Access Compliance Report

Public Rights-of-Way

(Curb Ramps)

Intersection ID: 9348	Main Street: GUY_E_SUDDRETH_AV	Cross Street: RITCH_AV	Location: SW
ADA ID: 0D58F0CC88DD	Ramp Type: Perp	Initial Pass/Fail: Fail	Overall Compliance: No
Severity Score: 22.5			
Codes/Mitigation Info/Possible Solution		Field Measurements/Component Compliance

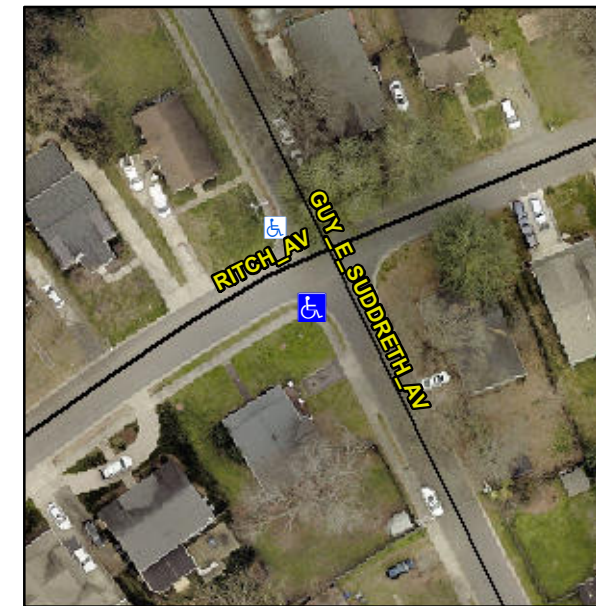
Not Found, R304.5.1, R304.2.2, R304.5.3

Compliance	Description	Data	Compliance	Description	Data
N/A	Ramp Length (in)	25.5	No	Ramp Slope (%)	9.4
No	Ramp Width (in)	39.0	No	Ramp XSlope (%)	2.4
N/A	Flare Type LT	N/A	N/A	Flare Type RT	N/A
N/A	Flare Slope LT (%)	N/A	N/A	Flare Slope RT (%)	N/A
N/A	Flare Traversable LT?	N/A	N/A	Flare Traversable RT?	N/A
N/A	Landing Length (in)	N/A	N/A	DWS Provided?	N/A
N/A	Landing Width (in)	N/A	N/A	DWS Contrast?	N/A
N/A	Landing Slope (%)	N/A	N/A	DWS Length (in)	N/A
N/A	Landing X Slope (%)	N/A	N/A	DWS Full Width?	N/A
N/A	Landing Curb? (Y/N)	N/A	N/A	DWS Offset (in)	N/A
N/A	Shared Landing?	N/A			
N/A	Gutter Ponding?	N/A	N/A	Gutter Slope (%)	N/A
N/A	Gutter Lip Ht (in)	N/A	N/A	Gutter X Slope (%)	N/A
N/A	Painted X Walk1?	No	N/A	Painted X Walk2?	N/A
	X Walk 1 Direction	To NW		X Walk 2 Direction	N/A
N/A	X Walk 1 Width (in)	N/A	N/A	X Walk 2 Width (in)	N/A
	X Walk 1 Slope (%)	3.3		X Walk 2 Slope (%)	N/A
	X Walk 1 X Slope (%)	1.6		X Walk 2 X Slope (%)	N/A

Remove & Replace Entire Ramp.
